City of Fairfax, Virginia  
City Council Work Session

Agenda Item # 8a  
City Council Meeting 7/11/2017

SUBJECT: Public hearing and Council action on a request of Regency Centers, LLC for five (5) special exceptions, an administrative appeal to the subdivision ordinance, and issuance of a Certificate of Appropriateness by City Council on the premises known as 10334-10406 Fairfax Boulevard and more particularly described as tax map parcel(s) 57-2-02-028 through 57-2-02-031.

SE-16120067

**Figure 3: Existing and Future Floodplain**

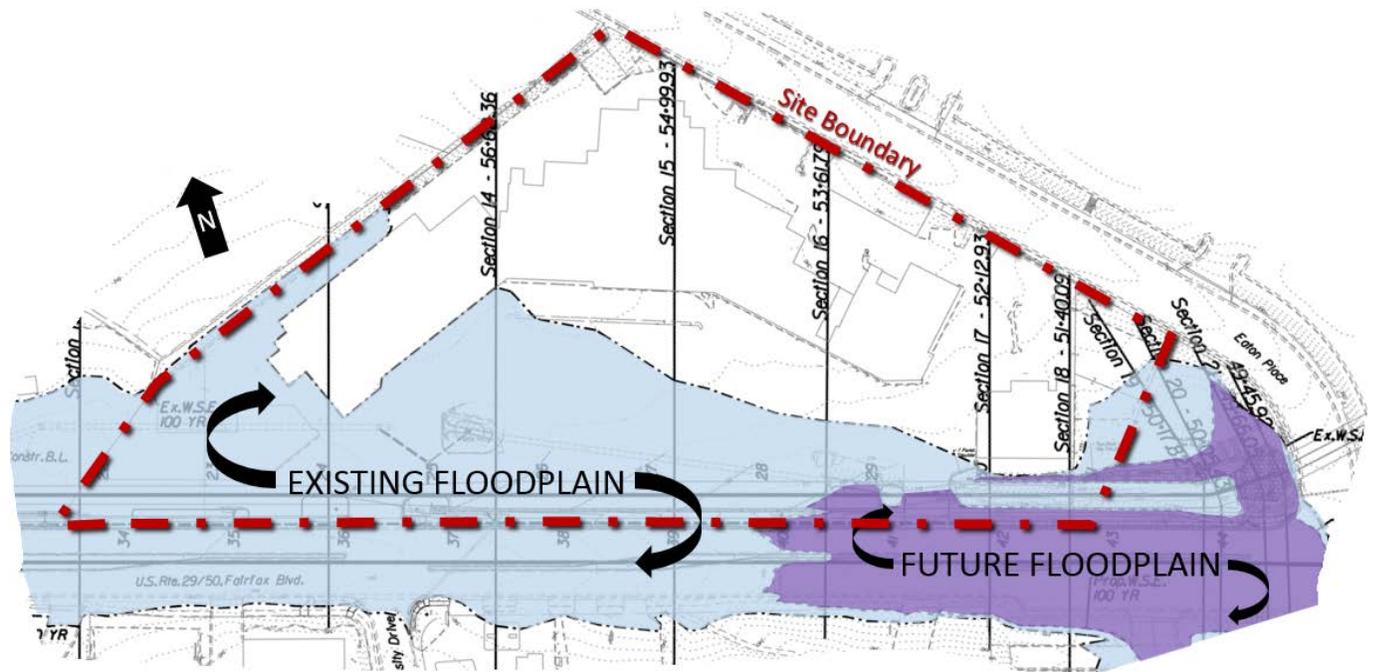
The site is currently impacted by the 100 year flood plain and the Chesapeake Bay Resource Protection Area. Both of these areas will be significantly diminished on the site as a byproduct of the Northfax project. Floodplain coverage is expected to be reduced from over 50% of the site area to just over 1% of the site area. The applicant does not propose any disturbance within the modified floodplain boundary once the Northfax project is complete. Construction and occupancy for areas within the existing floodplain would need to be coordinated with the timing of the Northfax project and issuance of a final Letter of Map Revision (LOMR)

from the Federal Emergency Management Agency (FEMA) confirming the change to the flood plain boundary. Condition 2 of the sample motion to approve (Attachment 11A) confirms that approval of land use requests associated with this application are subject to receipt of the LOMR for the Northfax project from FEMA.

2. Approval of these land use requests shall be subject to issuance of a Letter of Map Revision (LOMR) by the Federal Emergency Management Agency declaring that the extent of the flood plain on the site has been modified as a result of the Northfax Transportation and Stormwater Improvements Project (Northfax Project). The applicant may be required to request a Special Use Permit for disturbance in the floodplain if any areas proposed for disturbance are located within the revised floodplain boundary identified in the LOMR.

**FIGURE A-1: Proposed University Drive project with the proposed Fairfax Shopping Center site plan**

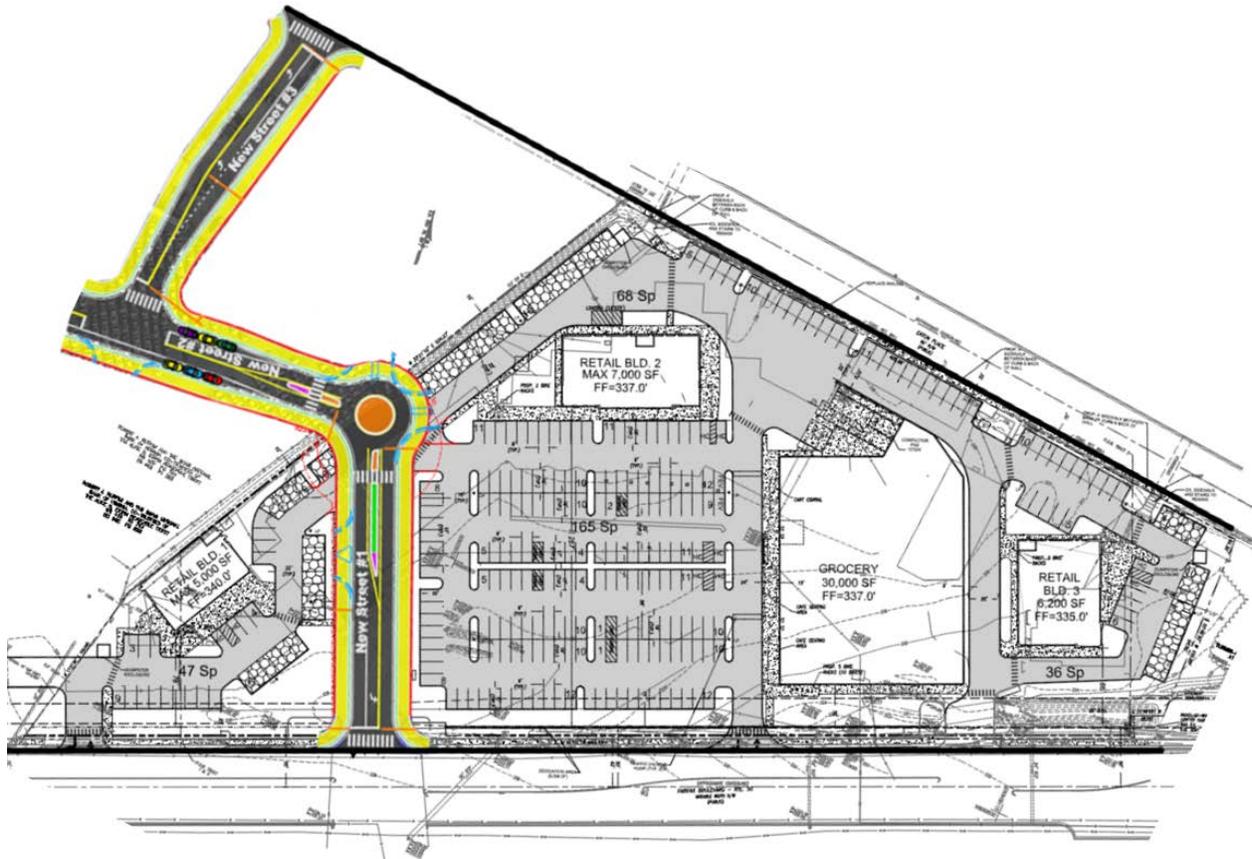
The site is currently bounded by Fairfax Boulevard to the south and Eaton Place to the north with vehicular access from four points along Fairfax Boulevard only. The applicant proposes to maintain four access point along Fairfax Boulevard but replace one access point near the western edge of the site with a new access point with right-in right-out access adjacent to the proposed grocery store. The primary access point would be at the existing traffic signal at University Drive and Fairfax Boulevard. During the application review, staff indicated a safety concern with the continued full access use of the eastern most access point which is unsignalized. Staff has recommended that left turn access be prohibited from this driveway to eastbound Fairfax Boulevard, though this has not been provided on the plans. Condition 5 on the sample motion to approve (Attachment 11A) clarifies that left turn access must be prohibited from this driveway.

The eastern driveway is designed to avoid any new impacts to the ultimate floodplain resulting from the Northfax Transportation and Stormwater Improvements Project (Northfax Project). This is further described under the Natural Resources section of this Analysis. This design results in a driveway apron over 40 feet in width to access a driveway that is just 25 feet in width. The applicant has not provided any explanation of how access would be managed to avoid confusion with this condition. Condition 8 on the sample motion to approve (Attachment 11A) states that this driveway should be modified with a reasonable driveway width during the site plan review phase and that the applicant shall apply for a Special Use Permit to City Council for disturbance in the floodplain should this need arise.

On June 13, 2017, City Council supported continued design of the University Drive Extension Project (University Drive Project), which provides a portion of the envisioned street grid for the Northfax Center, including new access to the site from Eaton Place. The approved plan for the University Drive Project as it relates to the proposed site plan is provided in Figure A-1. Notes 18 and 19 on Sheet 1 of the plans indicate that the applicant will coordinate with the City and it's consultants on the design of the University Drive Project, and may make reasonable modifications to the plans to accommodate the project during the administrative site plan review phase. Although the exact dates for construction and occupancy of the shopping center are unknown, it is anticipated that the shopping center would be in operation before the University Drive project is complete.

**FIGURE A-3: Proposed pedestrian network**

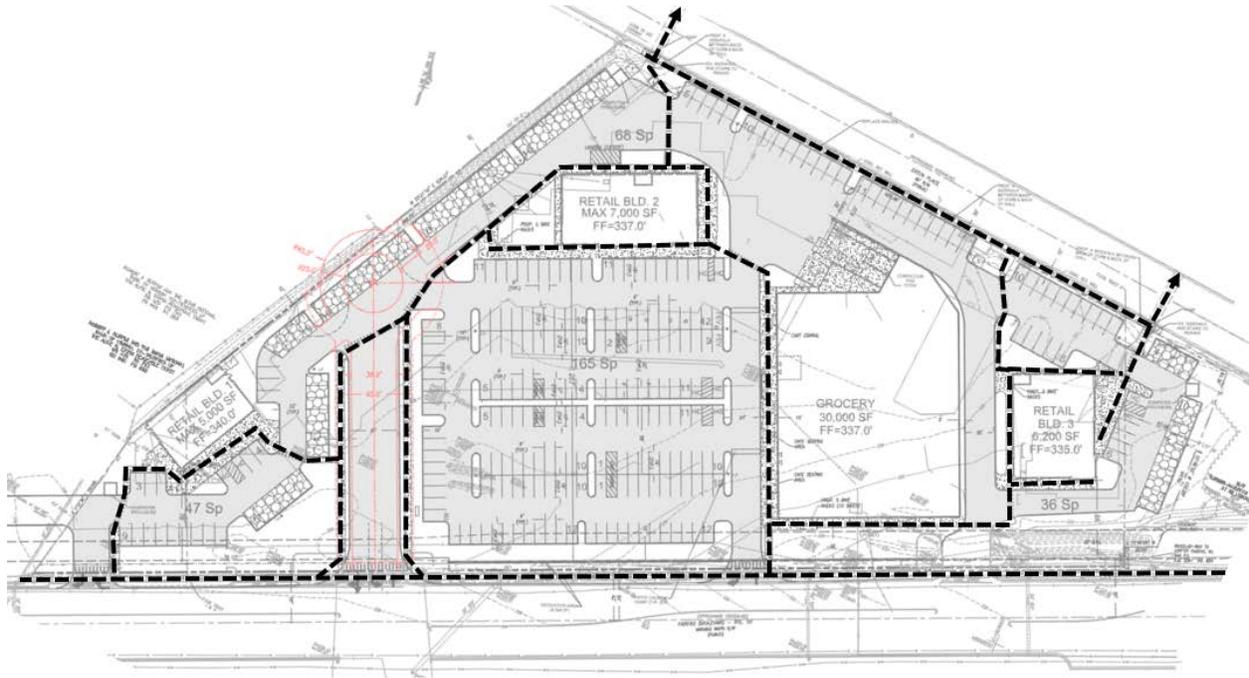
The proposed pedestrian network is generally improved from the existing condition with the addition of multiple pedestrian access points into the site from Fairfax Boulevard and cross-site access to Eaton Place. The existing access points on Eaton Place would remain. The zoning ordinance requires that mid-block connections be provided through all blocks over 600 feet in length. With the completion of the University Drive project, the subject site would make up the majority of a new block bounded by Fairfax Boulevard, University Drive and Eaton Place. This block length would be approximately 800 feet along Fairfax Boulevard and over 1,000 feet along Eaton Place. With this application, the maximum distance between mid-block connections would be approximately 500 feet along Fairfax Boulevard and 300 feet on Eaton Place. While the maximum length between pedestrian connections along Fairfax Boulevard is acceptable per the zoning ordinance, the submitted plan omits adequate pedestrian access between Fairfax Boulevard and

Building 3. Condition 6 in the sample motion to approve (Attachment 11A) requires pedestrian access near the eastern driveway entrance to serve Building 3.

6. An additional pedestrian accessway shall be provided near the eastern-most driveway connecting the Fairfax Boulevard sidewalk to Building 3. The specific location of this accessway shall be determined during the administrative site plan review period.
